North Little Rock Planning Commission
October 14, 2025 - Agenda / Public Hearing 4:00 PM
City Council Chambers – 300 Main Street, NLR, AR 72114

**North Little Rock Planning Commission
Minute Summary
September 9, 2025**

C1.0 - SITE PLAN REVIEW

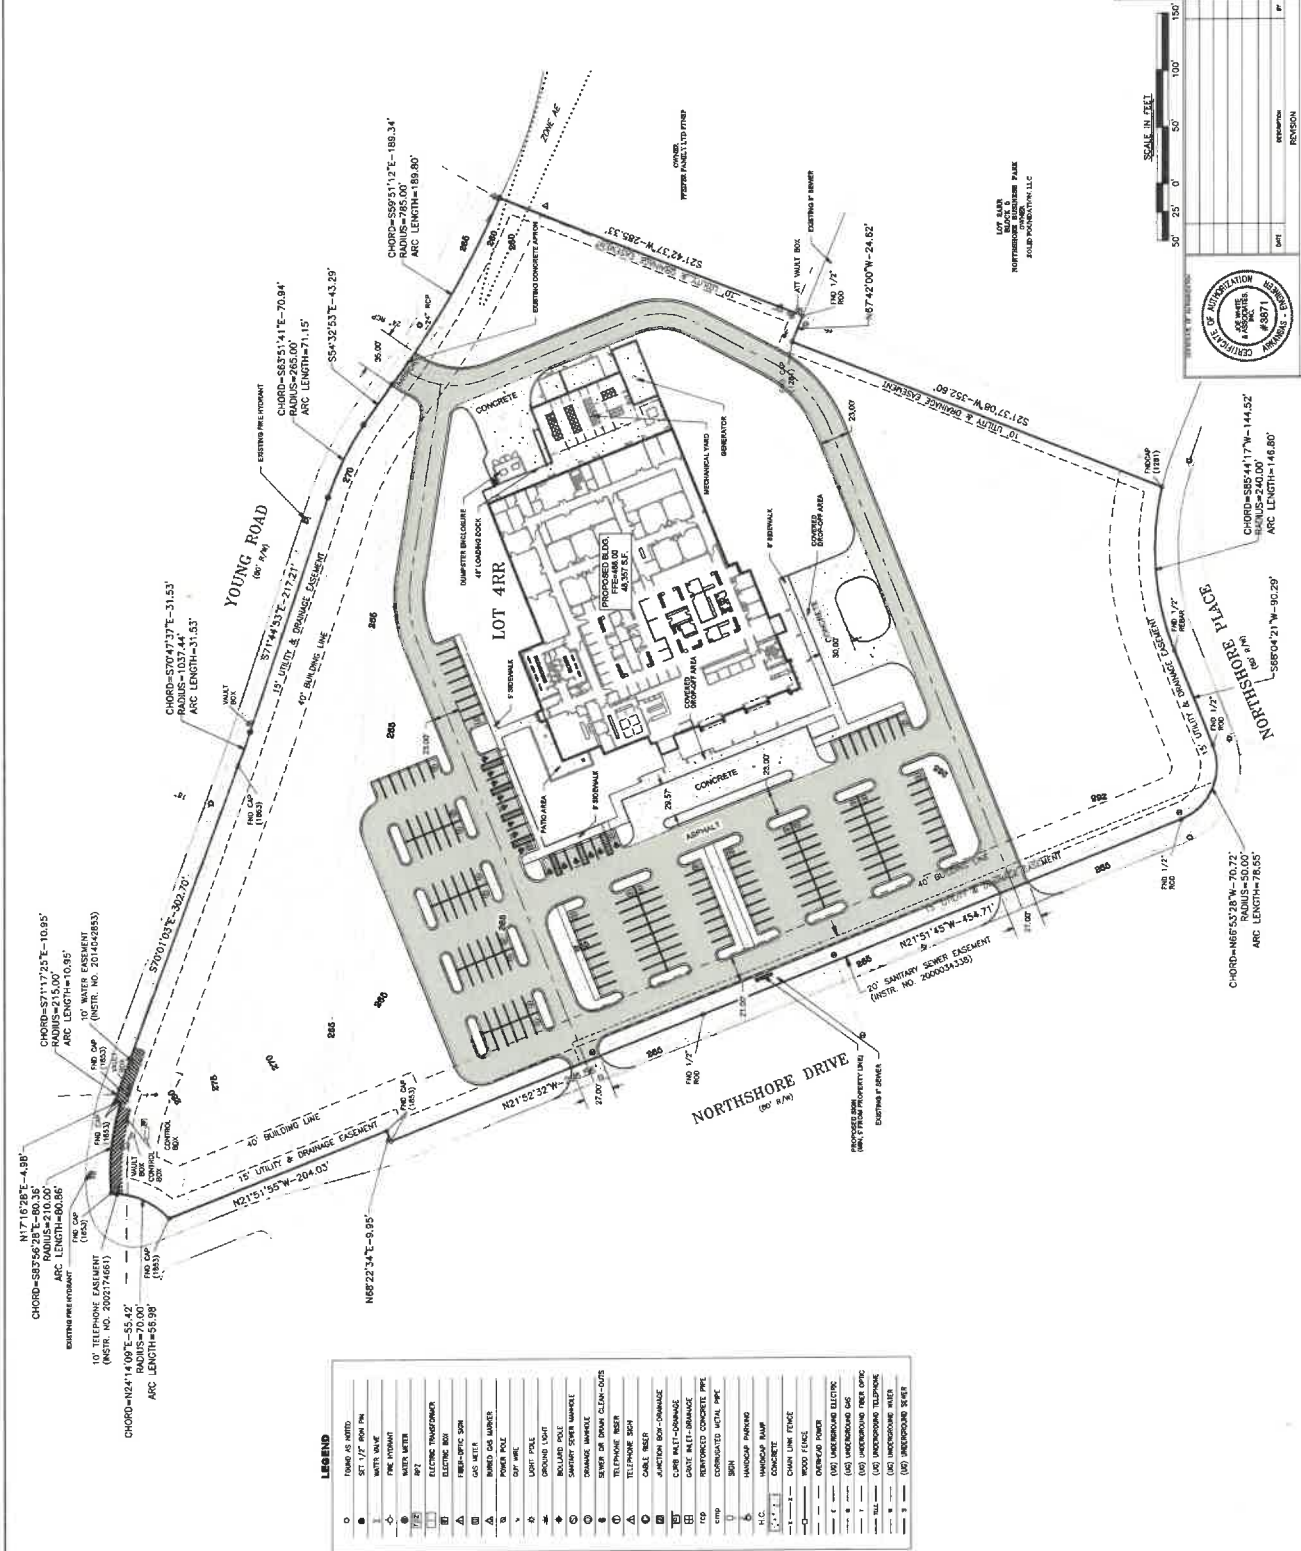
2. Permit requirements/approvals submitted before a building permit will be issued:
 - a. A signed and recorded plat must be on file with the Planning Department.

- b. If applicable, prior to construction, Owner's Engineer shall submit stormwater design report for review and approval by the City Engineer. Stormwater plans and detention calculations are to be approved by City Engineer and a written approval provided to Planning Department. Drainage submittal shall include, as a minimum, the following:

- a. Provide the standard requirements of Zoning and Development Regulations.
 - b. Provide dumpster location. Dumpster(s) are to have masonry screening on 3 sides along with an opaque gate enclosure.

- i. Provide note on landscape plan stating all turf and plant material shall be irrigated by an automatic underground irrigation system.
 - d. Provide street trees at a minimum rate 1 tree per 30 linear feet of property line adjacent to the street right-of-way.

- iv. A minimum of 33 trees will be required adjacent to the Young Dr right-of-way.
 - e. Trees shall be planted at the rate of one (1) tree per six (6) parking spaces.

- g. Provide a buffer/screening adjacent to the dissimilar land use to the east and south as defined by Section 7.2.4: Buffers between Dissimilar Uses.

- iv. A six (6) foot tall, continuous opaque screen shall be provided. An opaque screen may include one (1) of the following: wall, fence, site grading, or plantings. The opaque screen must be opaque in all seasons. Fabric screening is not allowable.

C1.0 - SITE PLAN REVIEW

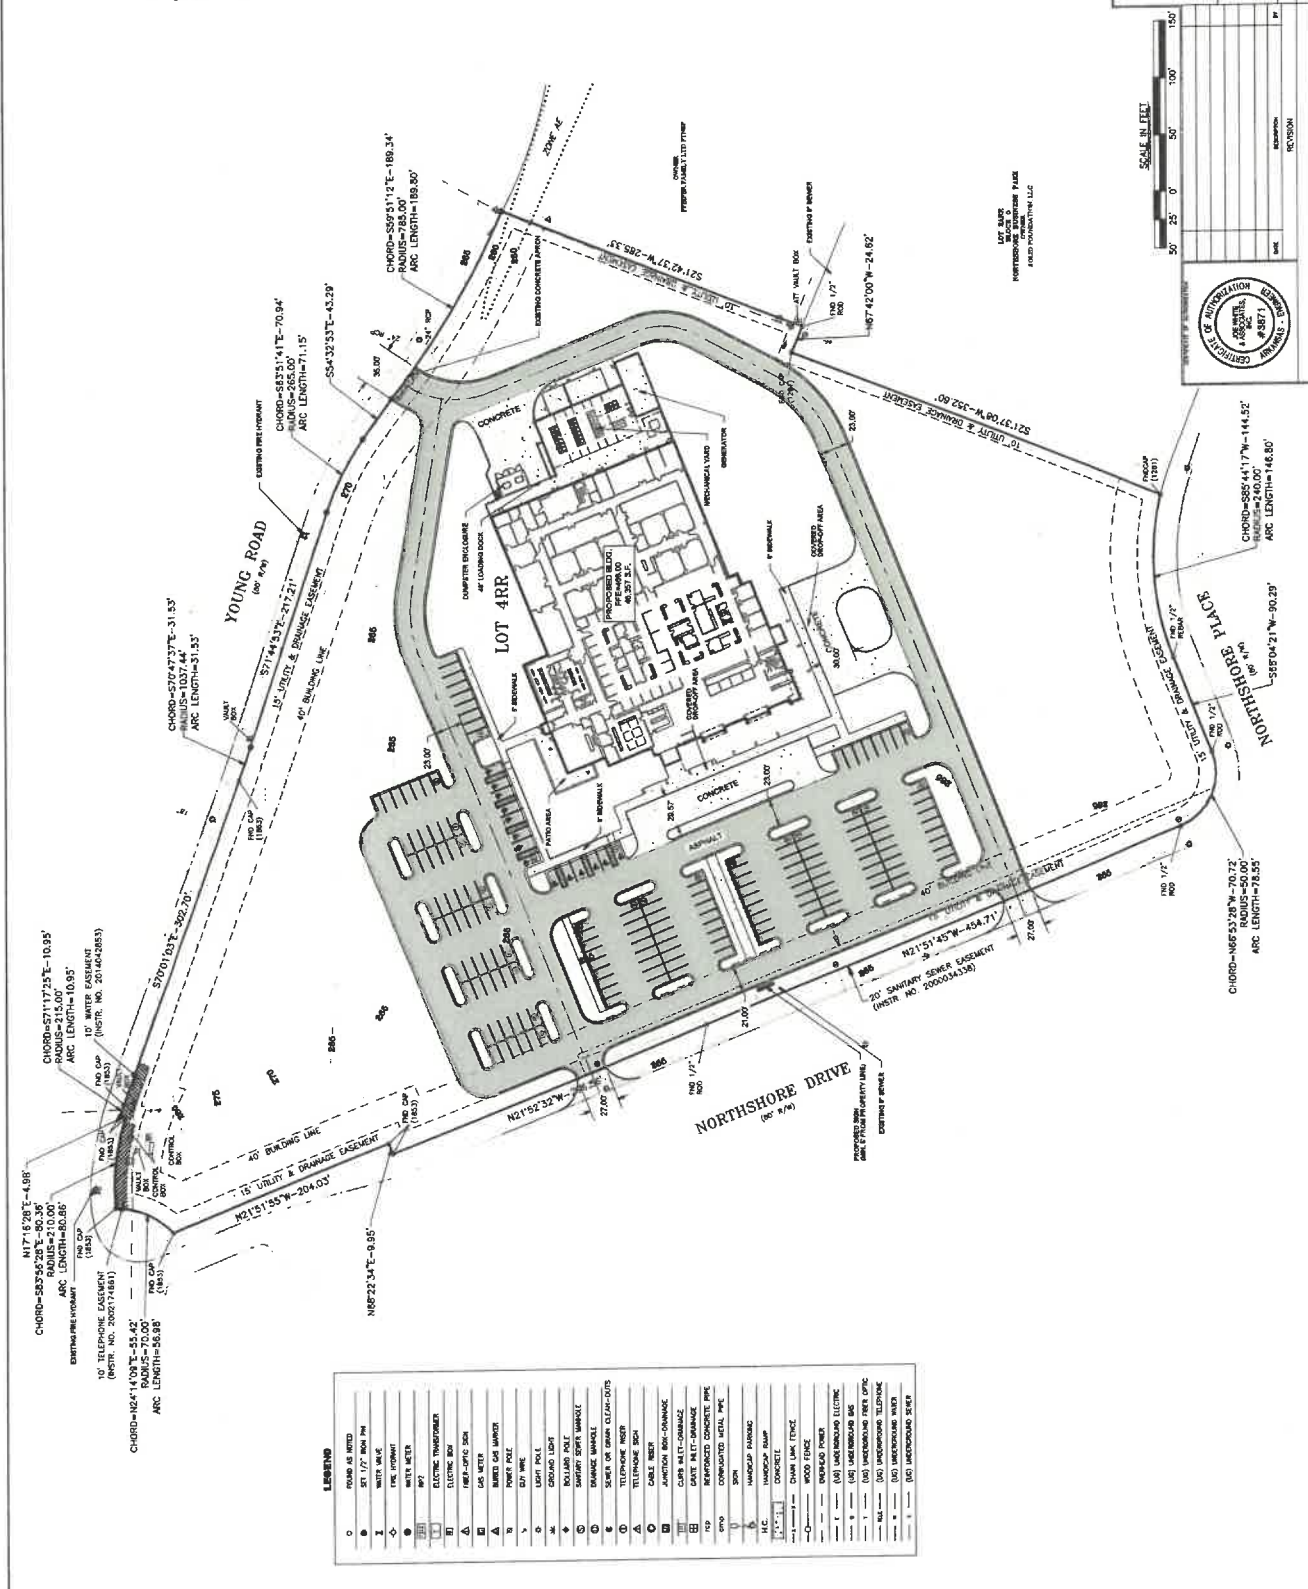
- b. Please contact NLRW Pretreatment Department for pretreatment and industrial permitting requirements.
 - c. Please submit a full set of plans to kunderwood@nlrwu.com for review and approval prior to construction begins.

DATE: AUGUST 2025
SHEET NO: C1.0 | | SITE PLAN
02-JF-2025
25047 | |

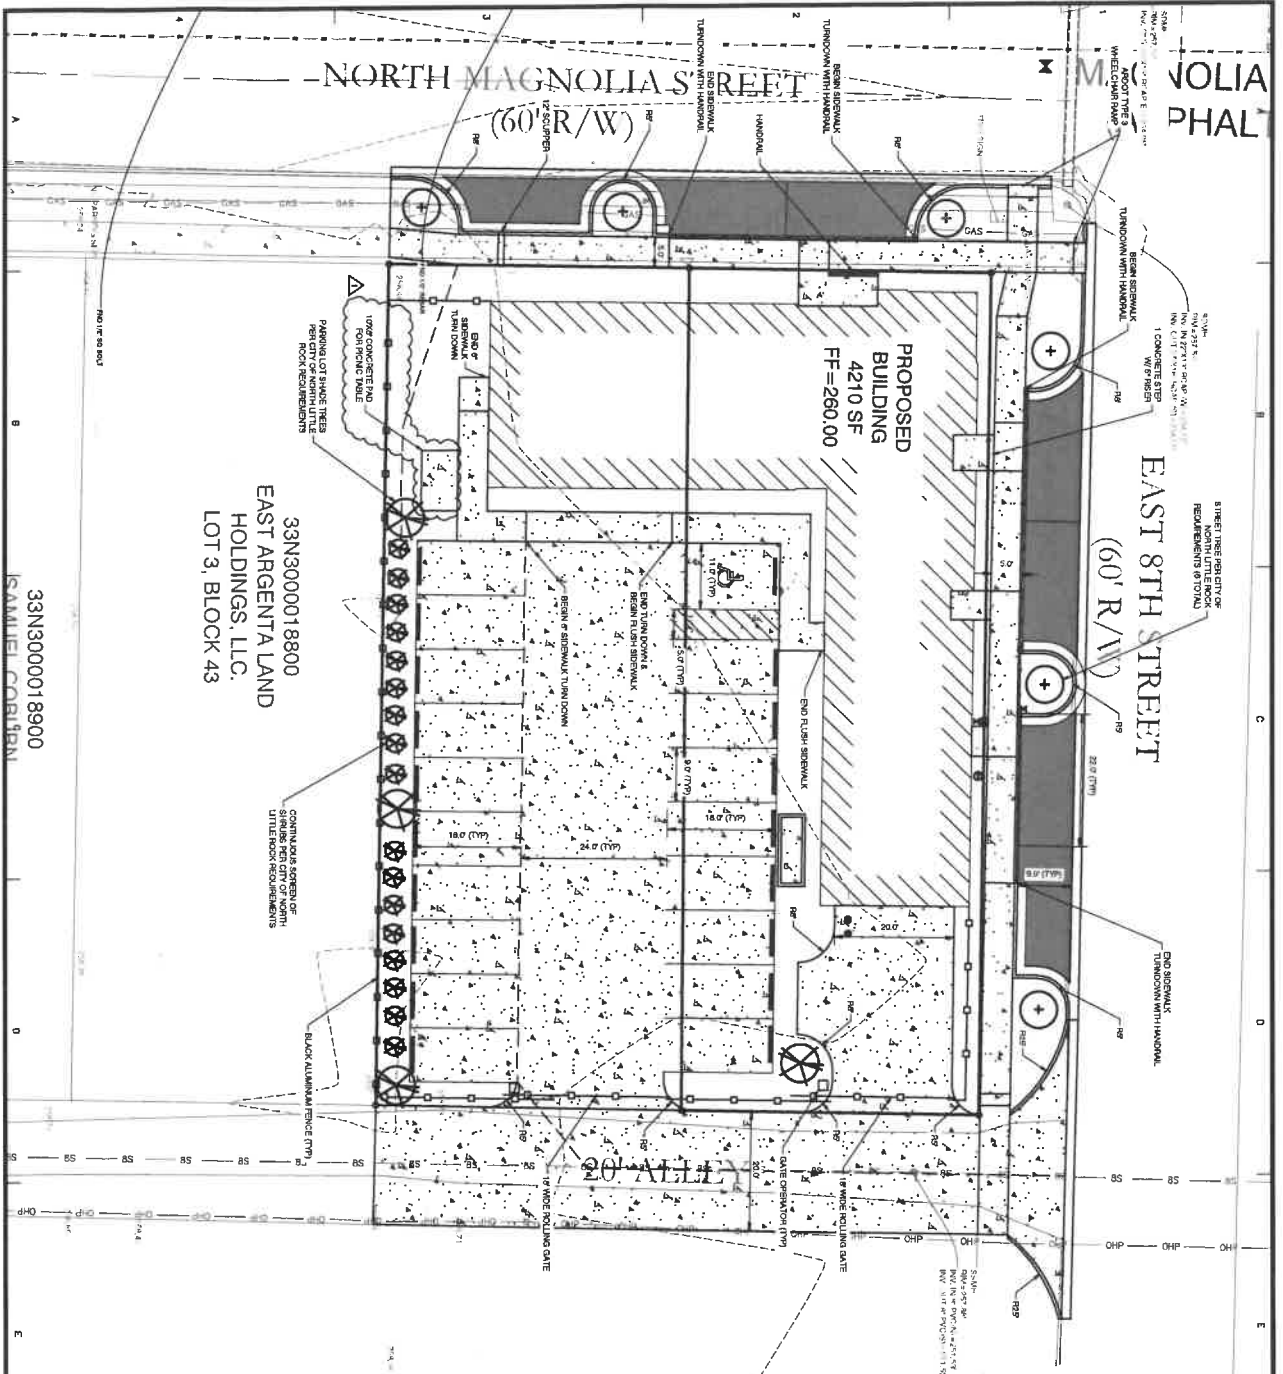
- a. Provide 5' sidewalks and ramps with a minimum of 5' green space between sidewalks and curb to ADA standards and City standards.
- b. Provide ROW dedication along Crystal Hill Road to meet the Master Street Plan.

- a. Any new site development must comply with the City's landscape and buffer ordinance requirements.
- b. **Provide a scaled landscape plan**, graphically indicating the plant material and locations, plant material legend graphically indicating the different plant materials, plant material list and specifications noting the minimum plant material size at installation.

- i. Provide note on landscape plan stating all turf and plant material shall be irrigated by an automatic underground irrigation system.
- c. Provide street trees at a minimum rate 1 tree per 30 linear feet of property line adjacent to the street right-of-way.
